**Town of Surfside
PLANNING & ZONING BOARD
AGENDA**

ADDENDUM NO. 1

FEBRUARY 24, 2022 – 6:00 p.m.

A. 9165 Collins Avenue – Site Plan Approval

SHEET NO. **A3.00**

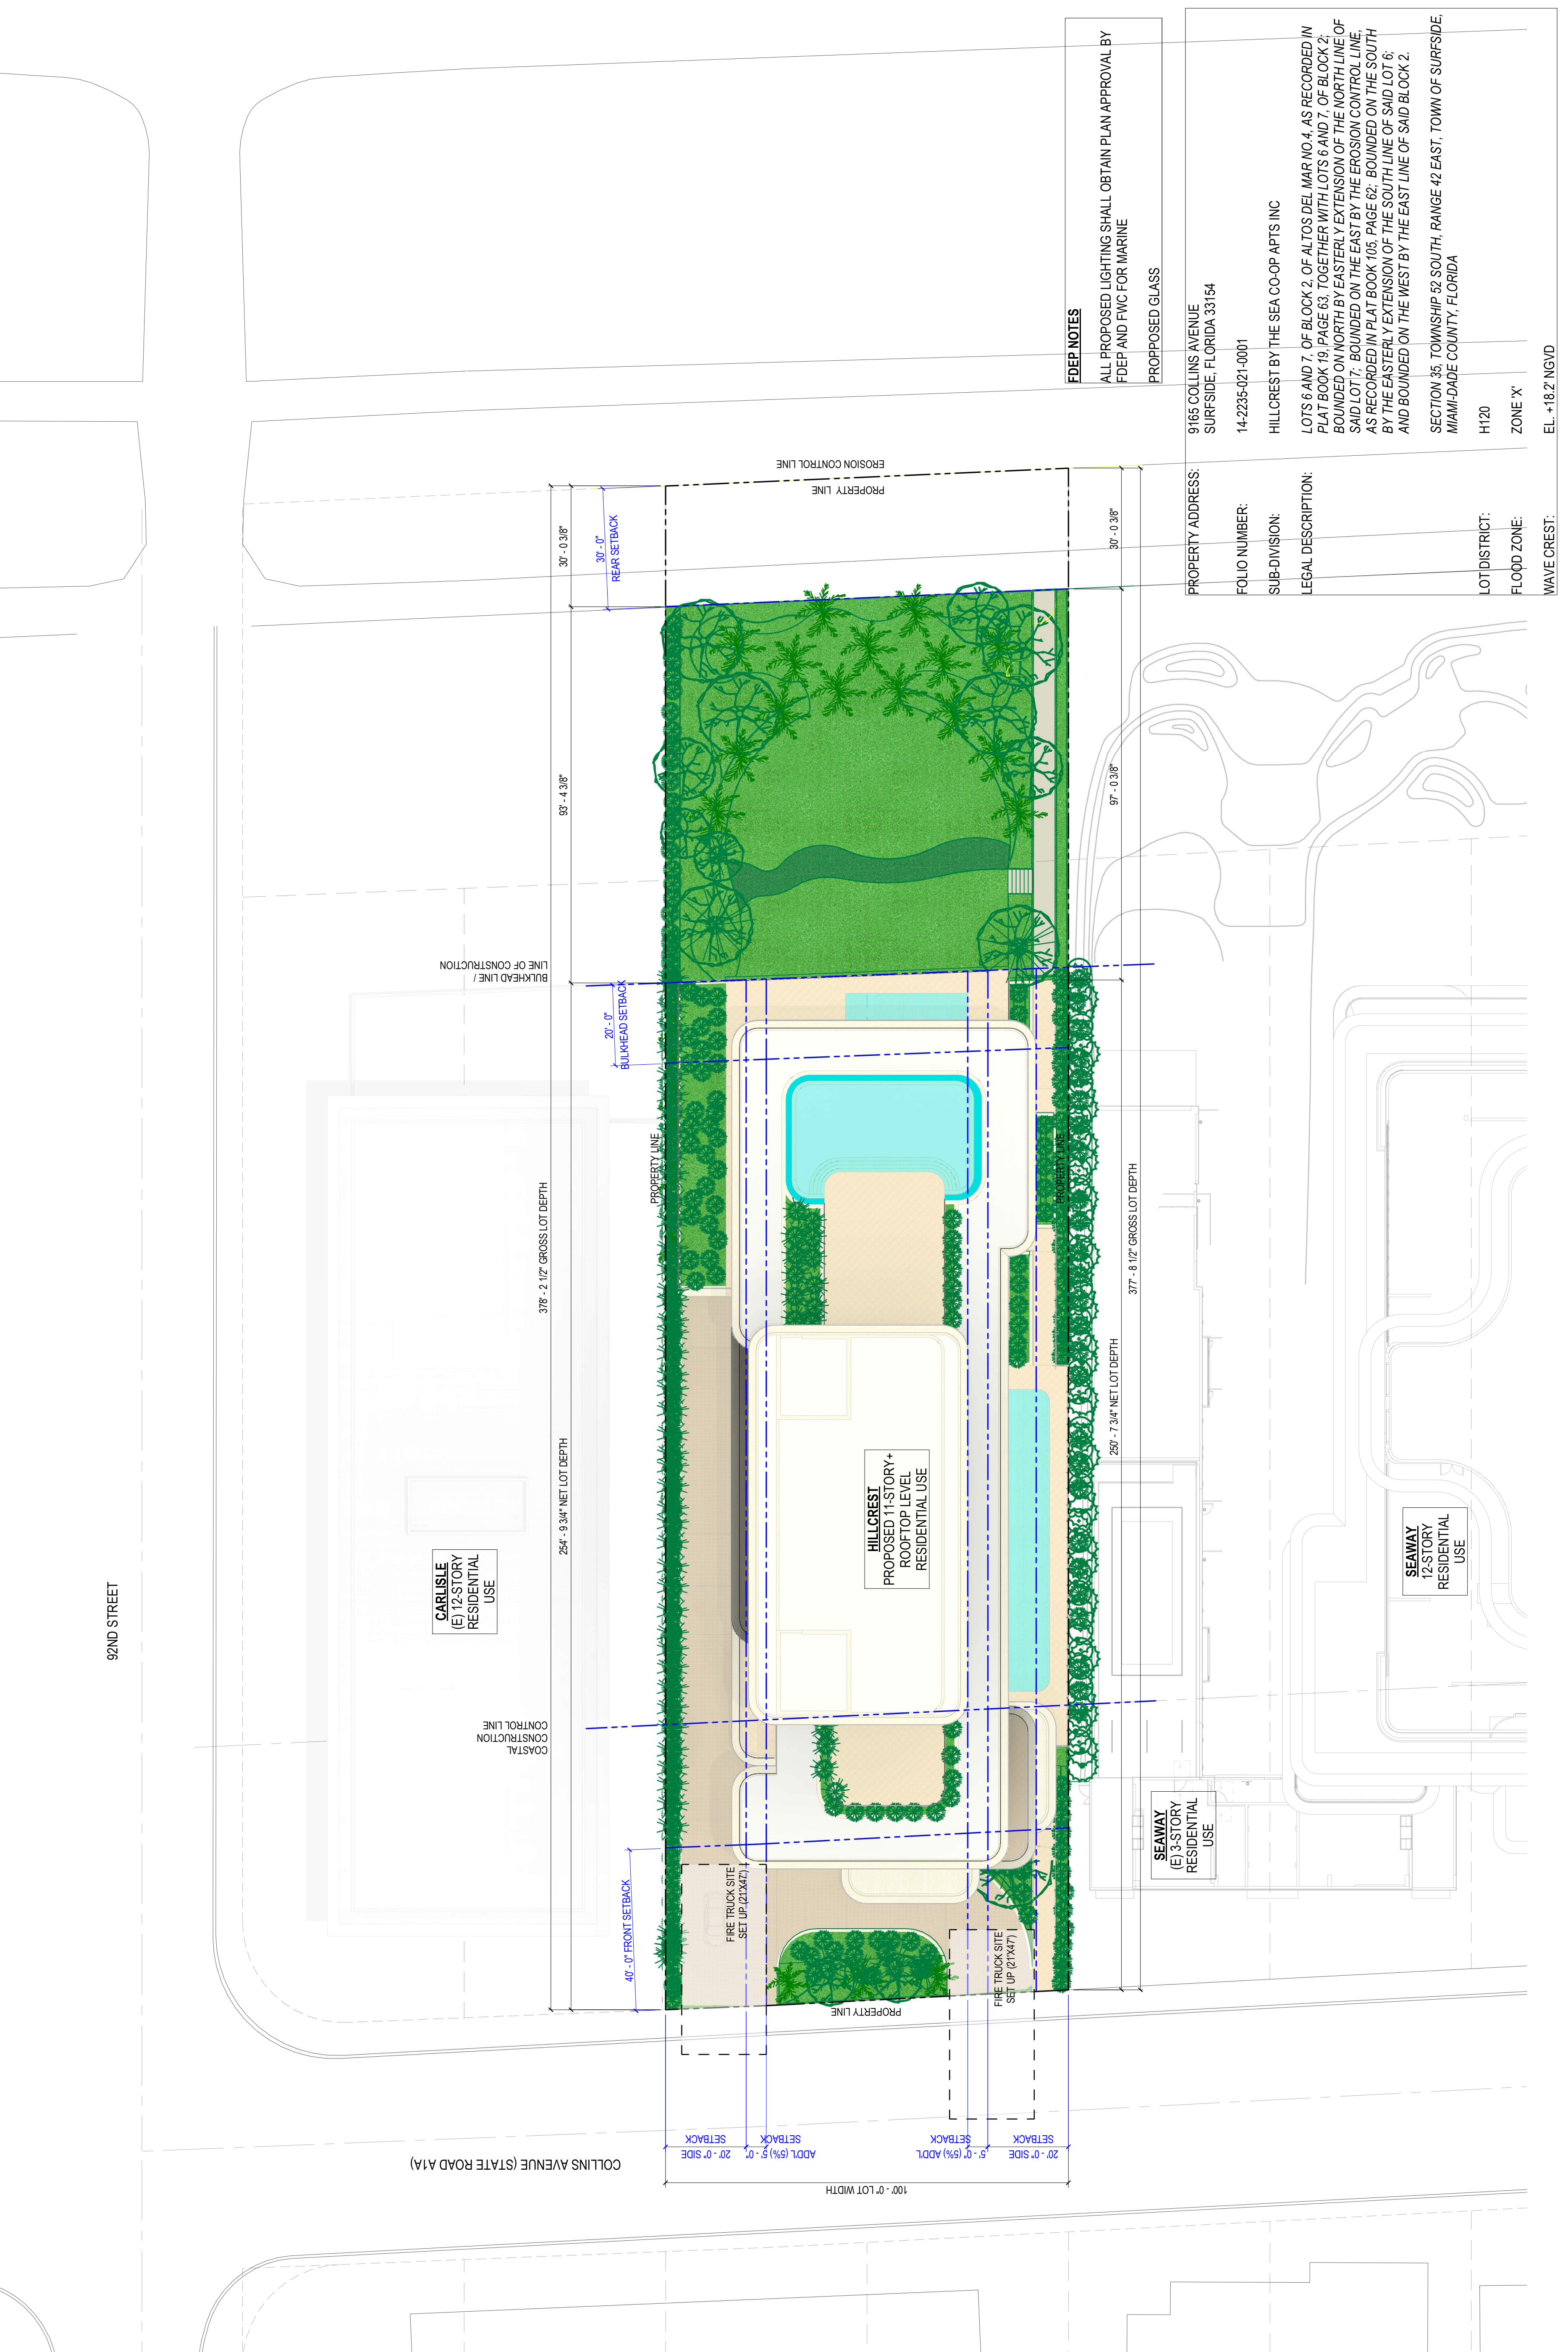
A landscape review was performed. Differences were noted between the Architectural Site Plan (Sheet A3.00) and the Landscape Site Plan (L-100). Previous area requirements for H120 are 20% and 25.6% is provided with the majority of the previous area occurring in the private recreation area east of the Bulkhead Line. The landscape plan utilizes the landscape treatment provided by the Seaway project on the south side of the property. The landscape plans did not include the required irrigation plan. Dimensions of the landscape buffers need to be provided between properties. A landscape calculation table needs to be provided indicating the minimum required and provided comparisons of the proposed plant material. Provide percentages of landscaping in VUA, street lengths, buffer lengths, percentages of Florida Friendly material and native/drought tolerance material. Proposed Green Buttonwood trees exceeds 30% of the same species and should be reduced in number. Oleander can be used as an accent but does not qualify as a required tree or Palm. The percentage of required trees being proposed as Palm trees should be provided.
